157th session

**1958 Agreement – Consideration of draft amendments
to existing Regulations submitted by GRPE**

Proposal for Supplement 1 to the 01 series of amendments to UN Regulation No. 101 (CO₂ emission/fuel consumption)

Submitted by the Working Party on Pollution and Energy*

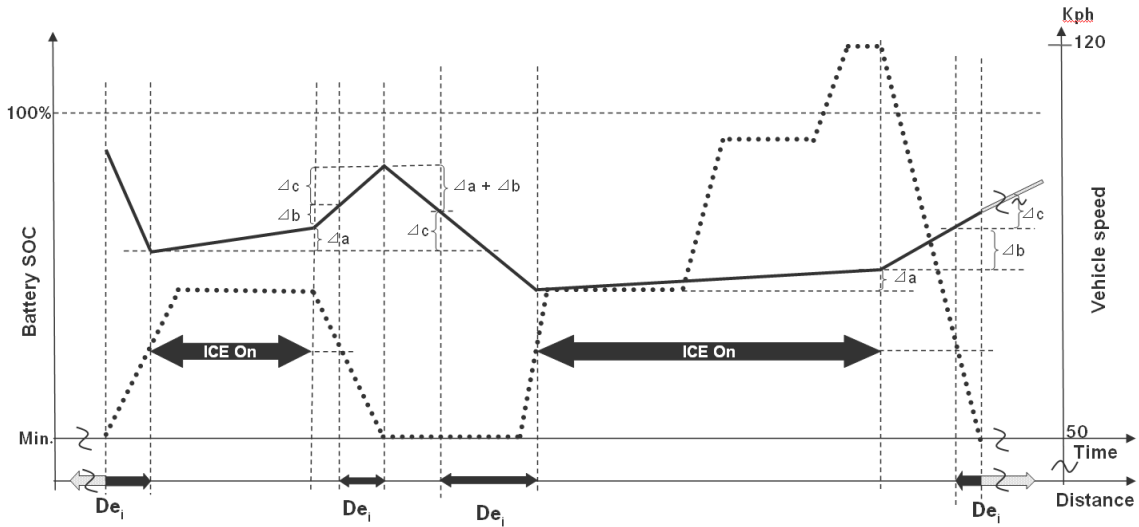
- 4.2.2.1.3.1. During the first deceleration phase following each start of the fuel consuming engine, when the vehicle speed is less than the vehicle speed at which the fuel consuming engine started previously
- (a) The distance covered with engine off should be counted as De_i; and
 - (b) The increase in electricity balance during this period should be recorded (ΔQrb_i); and
 - (c) The electricity balance when the fuel consuming engine starts (QES_i) defined previously should be corrected by ΔQrb_i (hence new QSA_i= QES_i + ΔQrb_i);

VES_i: Vehicle speed at the moment when the ICE starts;

QES_i: Energy of the battery at the moment when the ICE starts;

ΔQrb_i: The increase in electricity balance during deceleration phases, when the vehicle speed is less than the vehicle speed at which the ICE started previously;

QSA_i: Energy of the battery at the moment of the further accumulation of De.
